SAFETY EVALUATION BY THE OFFICE OF NUCLEAR REACTOR REGULATION

R. E. GINNA NUCLEAR POWER PLANT

DOCKET NO. 50-244

TUBE SHEET SLEEVE

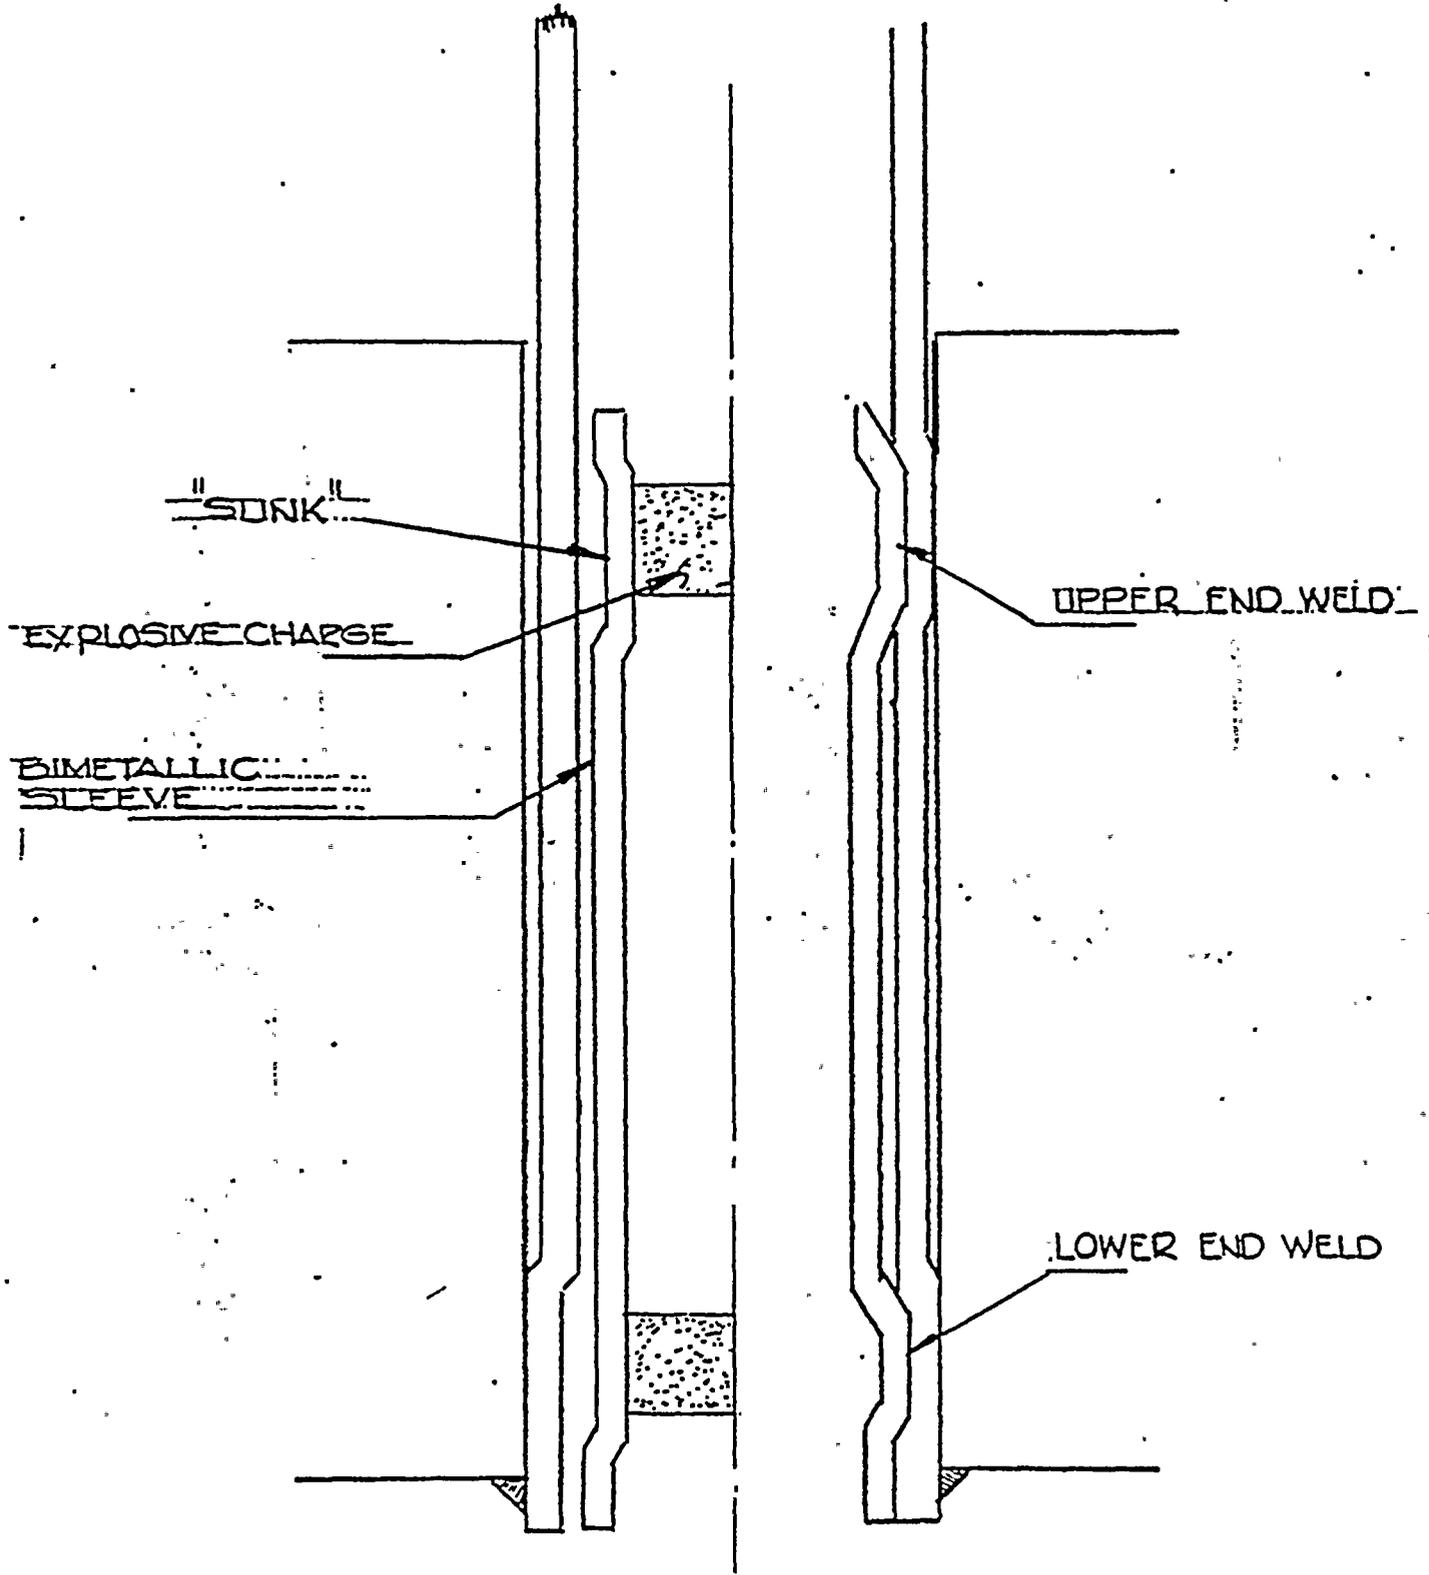
In order to provide the capability for sleeving these tubes, RG&E has developed a modification to the approved sleeve design (see Attachment 1). The modification, called a tubesheet sleeve, is explosively welded at both the bottom and top. The current tubesheet sleeve design is 22 inches long. However, RG&E anticipates the development of shorter lengths in the future. The tubesheet sleeve is designed to repair tube defects which occur within the tubesheet. The tubesheet sleeve is manufactured from the same 0.745 inch nominal O.D., bimetallic tubing as the sleeves. The lower tubesheet sleeve-to-tube joint uses the same configuration and explosive weld process as the brazed sleeves.

The upper tubesheet sleeve-to-tube joint also is made using an explosive welding process. The design of the weld is based on that used previously for the lower end joint which has been approved by the staff. The upper weld is made prior to making the lower end weld using a separate cartridge and detonation. The upper weld is the same length (0.75 inches) as the lower one, with its upper end a minimum of 1 inch below the top of the tubesheet. The sleeve O.D. is locally reduced over a length of 2 inches at the upper joint to provide the necessary weld standoff distance. The I.D. of the tube to be sleeved is cleaned by honing and dry swabbing prior to installation of the tubesheet sleeve. The weld configuration and installation procedure were developed using a series of tests. Test welded joints have been examined by metallographic examination to confirm their adequacy. The final configuration and welding procedure have been qualified to Section XI of the ASME Code in the same manner as the lower end joint of the brazed sleeve joint. All qualification specimens achieved the minimum weld length of 0.75 inch.

During its review, the staff developed a number of concerns related to the adequacy of the inspectability of the part of the original steam generator tube located behind the upper expansion transition end of the tubesheet sleeve. In order to resolve this, the staff's consultant was

to make recommendations based on his site visit. He concluded that the inspection procedures used this time were adequate to ensure tube integrity for this outage and base-line sleeve inspection but that a more effective inspection technique will be needed at future outages which may require additional eddy current testing techniques such as multiple frequency and multiple pancake coil arrays. The staff agrees with the consultant's conclusions and recommends that RG&E investigate and develop as necessary an improved inspection technique to ensure the future inspectability of the tubesheet sleeve.

Because of the concerns previously indicated, the staff concludes that tubesheet sleeving of no more than 30 tubes is acceptable. Additional tubesheet sleeving shall not be performed until the licensee has demonstrated the effectiveness of its inspection techniques to the satisfaction of the staff. The staff also concludes that the inspection procedure for this inspection and the tubesheet explosively welded sleeve method are acceptable.
